CR Mated Test Fixture Insertion Loss (Comment #357)

Howard Heck, Jason Ellison, Megha Shanbhag, Nathan Tracy

Week of Sept 15, 2025

Figure 179A-1—Host-Nominal to Host-Nominal, Cable assembly, and test fixture insertion loss at 53.125 GHz

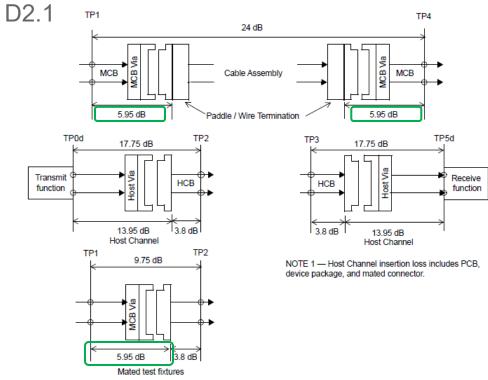
- MTF loss specifications:
 - TP1-TP2 = 9.75 dB
 - HCB from TP2 to connector = 3.8 dB
 - MCB from TP1 to the far side of the connector = 5.95 dB

MCB loss specification therefore includes PCB, PCB via and the via+connector.

- Through D1.4, the MCB loss was specified as PCB only with a value of 2.7 dB, allocating 3.25 dB for the via+connector.
 - Note: Cable assemblies to date have been measured with MCBs designed to the 2.7 dB trace insertion loss.

- Measurement of MTFs are showing via+connector loss to be in the range of 2.25 dB.
 - Since MCB loss specification includes the via+connector, the MCB traces require 1 dB <u>additional</u> loss to compensate for the lower via+connector loss.

- Based on all drafts since D1.5, all CR cable assemblies should be measured with redesigned MCB's.
 - This increases the amount of MCB loss included in a TP1-TP4 cable assembly measurement by 2 dB, effectively reducing cable assembly portion of the loss by 2 dB (2 MCBs in a measurement), compromising the ability to meet the existing TP1-TP4 insertion loss specs. We do not believe this was the intent of the change made in D1.5

Figure 179A-1—Host-Nominal to Host-Nominal, Cable assembly, and test fixture insertion loss at 53.125 GHz

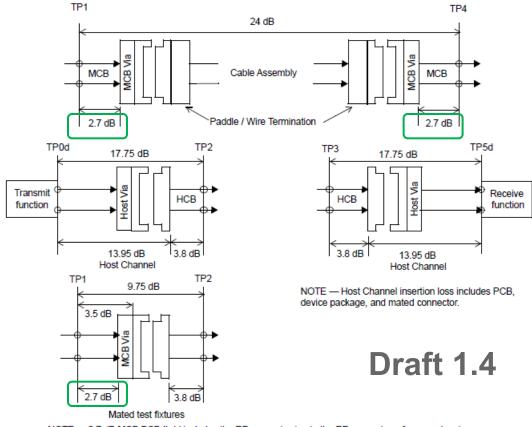
Return to the insertion specification in Figure 179A-1 from Draft 1.4.

NOTE — 2.7 dB MCB PCB ILdd includes the RF connector (up to the RF connector reference plane).

The recommended maximum differential insertion loss (TP0d-to-TP2) or (TP3-to-TP5d) are consistent with the host channels and an assumed mated connector insertion loss of 2.45 dB.

Figure 179A–1—Host-Nominal to Host-Nominal, Cable assembly, and test fixture insertion loss at 53.125 GHz

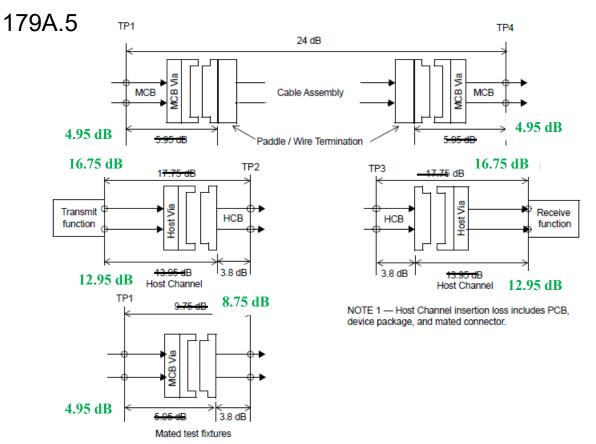
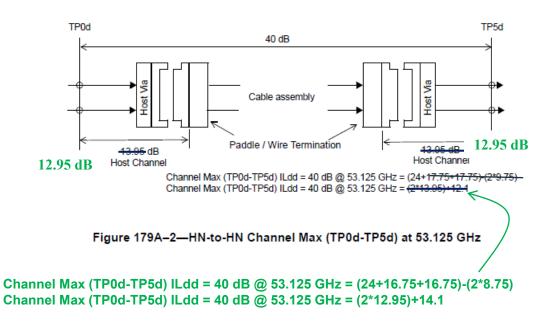
Proposed Changes - Option 2 (Preferred)

Note: The change in host channel loss is due solely to reduced connector loss. Host routing is not affected.

NOTE 2 — The MCB and HCB ILdd allocations include the RF connector (up to the RF connector reference plane).

MCB = Module Compliance Board, 179B.3 HCB = Host Compliance Board, 179B.2 MCB Via = transition via to MDI connector on an MCB Host Via = transition via to MDI connector on a Host Channel Paddle/Wire Termination = transition structure(s) in a Cable Assembly not present on an HCB
